UNITED STATES ENVIRONMENTAL PROTECTION AGENCY
REGION 8

Re: Final Major Permit Modification to Reconstruct the Suckla Farms No. 1,
Weld County, Colorado, Permit No. CO10938-02115, API No. 05-123-14291

FINAL MAJOR MODIFICATION
for
APPENDIX A CONSTRUCTION PROCEDURE

Final Major Permit Modification

Modified Diagram
Suckla Farms #1 Disposal Well
 SENW, 500 feet (ft.) from the south line and 2020 ft. from the west line, Section 10,
 Township 1 North, Range 67 West, Weld County, Colorado
 API No. 05-123-14291

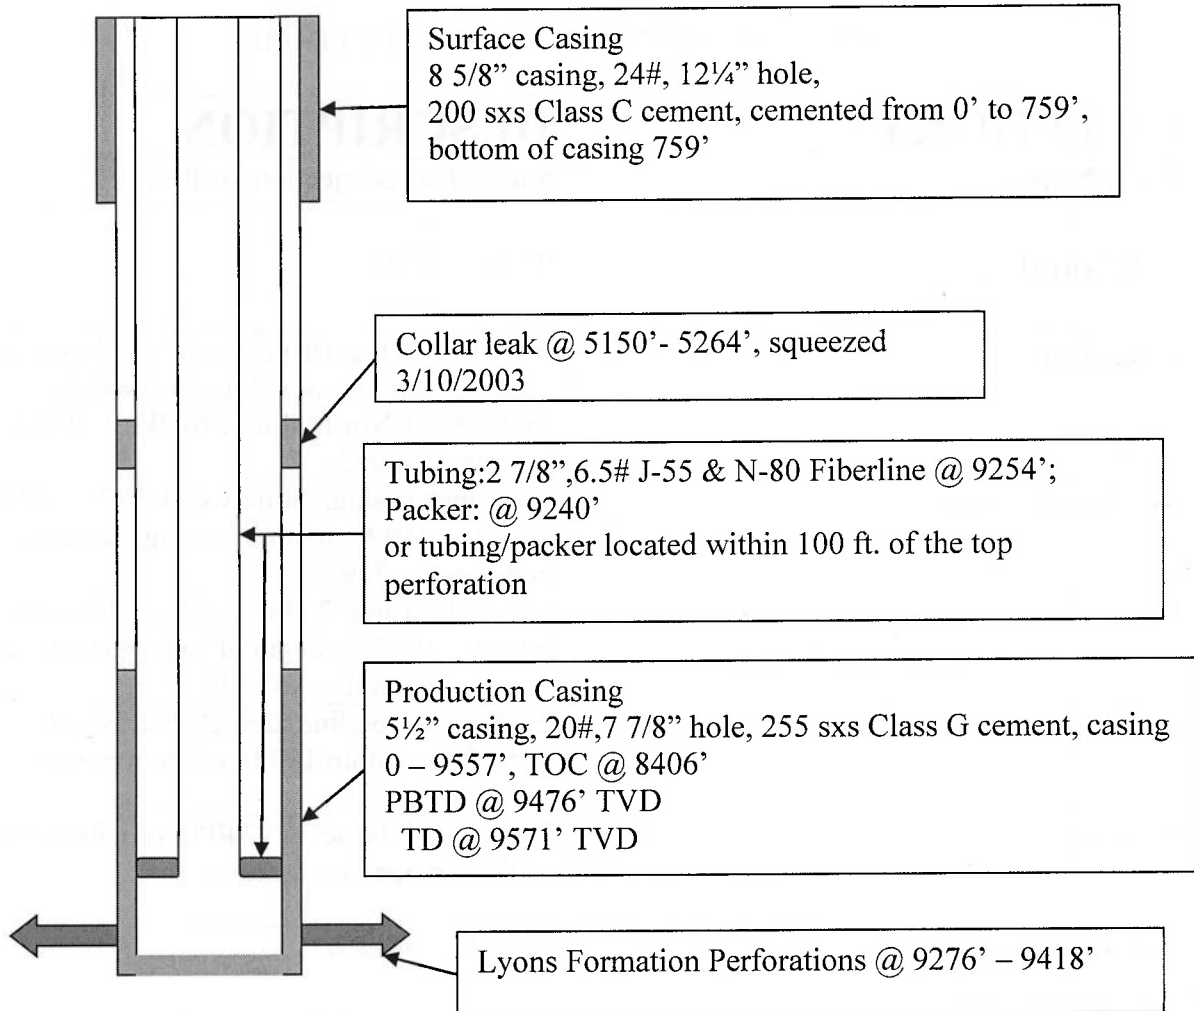
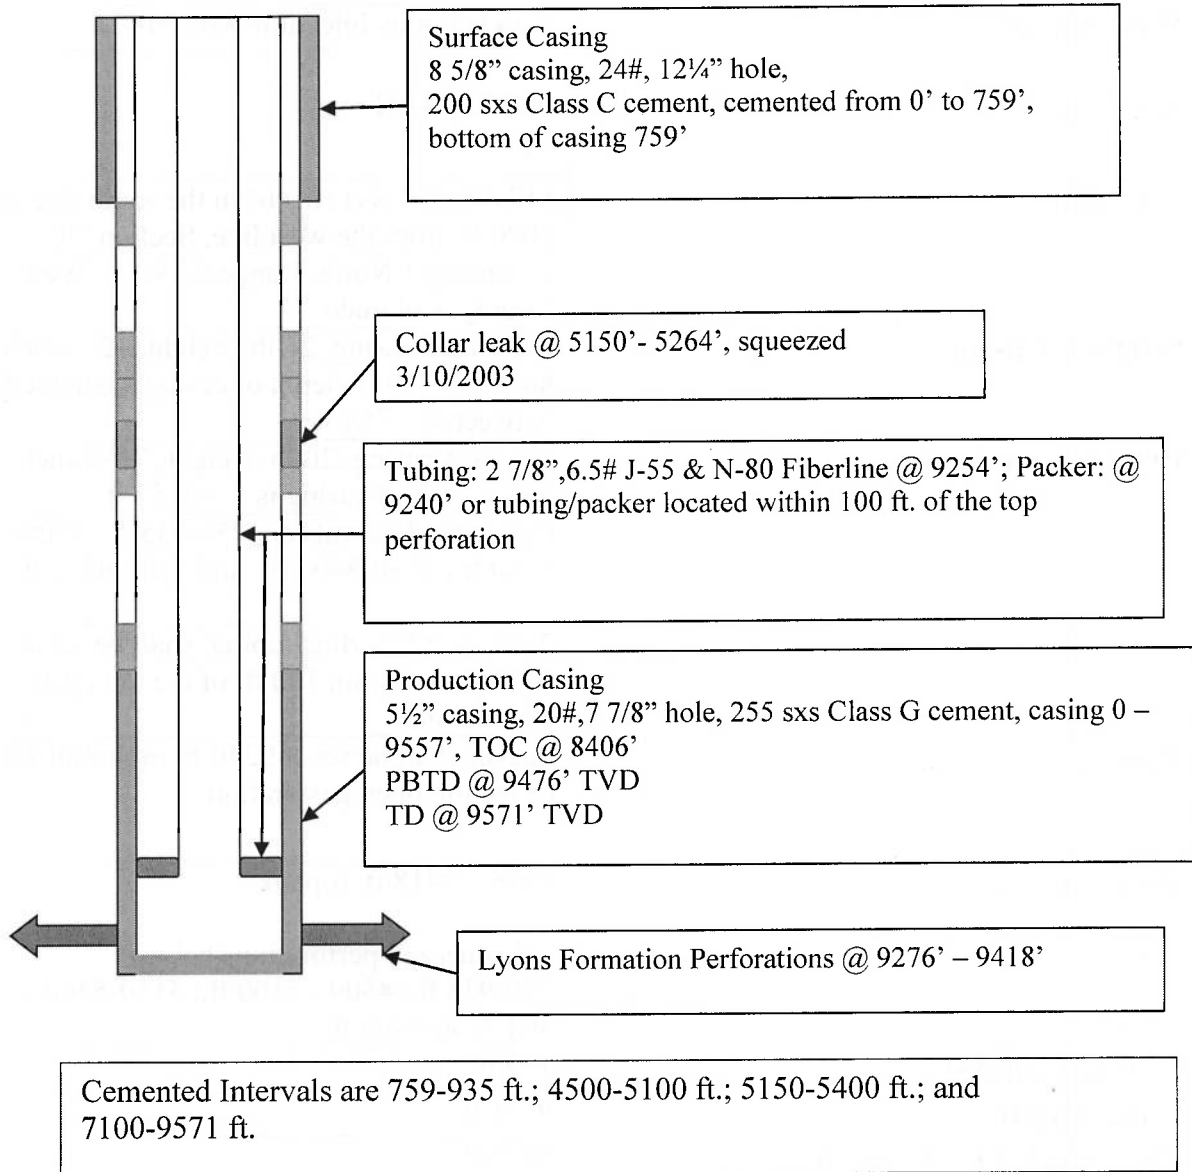
Modified Language

CATEGORY	DESCRIPTION
Well Name	Suckla Farms Injection Well #1
API Number	05-123-14291
Location	SE ¹ / ₄ NW ¹ / ₄ , 500 feet (ft.) from the south line and 2020 ft. from the west line, Section 10, Township 1 North, Range 67 West, Weld County, Colorado
Surface Casing	8 5/8-inch casing, 24 lb. weight, 12 1/4 inch hole, 0 – 759 ft. depth of casing, cemented between 0 – 759 ft.
Production Casing	5 1/2 inch casing, 20 lb. weight, 7 7/8-inch hole, depth of casing is 0 – 9557 ft. Cemented Intervals are 759-935 ft.; 4500-5100 ft.; 5150-5400 ft.; and 7100-9571 ft.
Tubing	2 7/8 inch Fiberline tubing, shall be set at 9254 ft. or within 100 ft. of the top open perforation
Packer	Packer shall be set at 9240 ft. or within 100 ft. of the top open perforation
Perforations	9276 – 9418 ft. (open) All squeezed perforations below: 759-935 ft.; 4500 - 5100 ft.; 5150-5400 ft.; and 7100-8406 ft.
Top of Cement	759 ft.
Total Depth	9571 ft.

Plug Back Total Depth	9476 ft.
Depths are approximate and will be verified with a Cement Bond Log (CBL) following the completion of all well reconstruction activities. A well completion form and Part I mechanical integrity test results will also be required.
